Final Report

Taro East Landfill Expert Panel

October 2000

Figure 2
Chloride Concentration for East Landfill Leachate

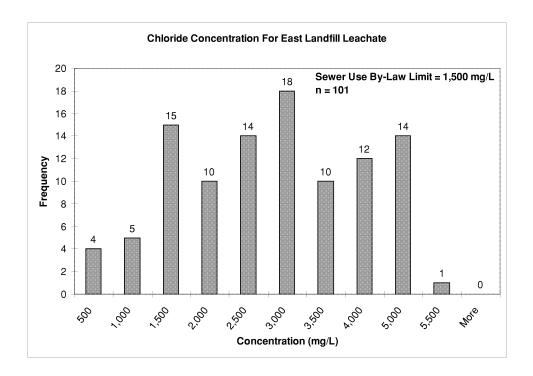
It is evident that the leachate from Taro East does not meet the Hamilton By-Law for chloride (or sulphate) concentration. Nor has a "compliance agreement" been established for Taro East as has been done for Taro West. Figure 2 shows the distribution of chloride concentration results reported by Taro for the East Landfill leachate.

Chloride in the leachate is an issue because the Hamilton-Wentworth Sewer Use By-Law limits chloride to a maximum of 1500 mg/L, a level which is usually exceeded in East Landfill leachate (see Figure 2) as well as the other leachates mentioned earlier, including the West landfill.

- 6. The Panel recommends that any discharge of East Landfill leachate should be subject to the following conditions:
 - a) The impact of the Taro West and East Landfill leachate on the Woodward Avenue WWTP should be evaluated through experimental wastewater treatment pilot plant tests together with scans for metals and trace organics removals and accumulation in biosolids. Discharging of East leachate to the Woodward WWTP should only occur if these tests show that is acceptable.

- b) In lieu of a chloride removal pre-treatment plant (and given savings realized by not building the plant and by eliminating the trucking and handling of leachate off-site), the Company should provide funding (to be negotiated with the Region) for using the sewer system.

Figure 5
Total Suspended Particulate - % exceedances (samples)

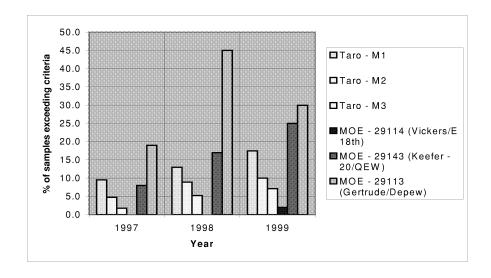
Table 4 and Figure 5 do indicate that there have been more exceedances of the 24-hour criteria at Taro than at Vickers and 18th. This can be attributed to the quarrying and material handling operations at the site. Similar major construction sources are not present around the Vicker's station. These exceedances are significantly below the percentage of exceedances at the other two sites.

- 1. Add fine particulate monitors to the air quality monitoring program. Specifically, PM2.5 monitoring should be included.
- 2. The design of an appropriate network and approach for air quality monitoring should be developed in consultation with the CLC.
- 3. Consideration should be given to locating a PM2.5 monitor within the nearby community to demonstrate the differences in dust levels measured at the property boundary of the site and within the community. This monitor could be located in different areas for six month to one year periods to determine particulate levels in specific locations.

Figure 6 Volatile Organic Compounds

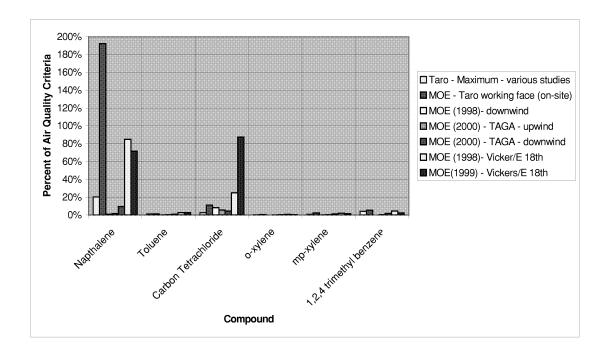
Modifications to the Leachate Extraction Procedure will provide more detail and control over VOCs in the waste and should provide a better understanding of possible emissions, but new volatile organic compounds can be formed in the landfill at any point in its life.

- 1. VOC monitoring by the Company should be continued annually.
- 2. The VOC monitoring should include a full (open) analytical scan to identify any changes to VOC emissions. This would be done by performing a full analytical scan and compound identification using a gas chromotagraphy mass spectrometry analysis. This should be done by a certified laboratory familiar with this type of analysis.
